Product Change Notification: E-19-005078

PCN Date: 17-JUN-19

Z-PACK Tinman, Assembly

change comparison

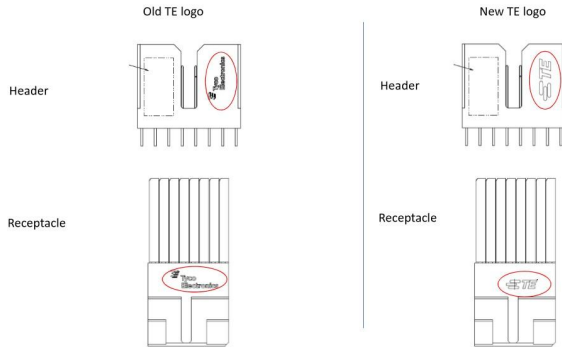
The drawings for the listed part numbers have been modified for clarification; Before: old TE logo on connector After: new TE logo on connector. no any real impact on connector performance and customer application. So we will apply this change directly.
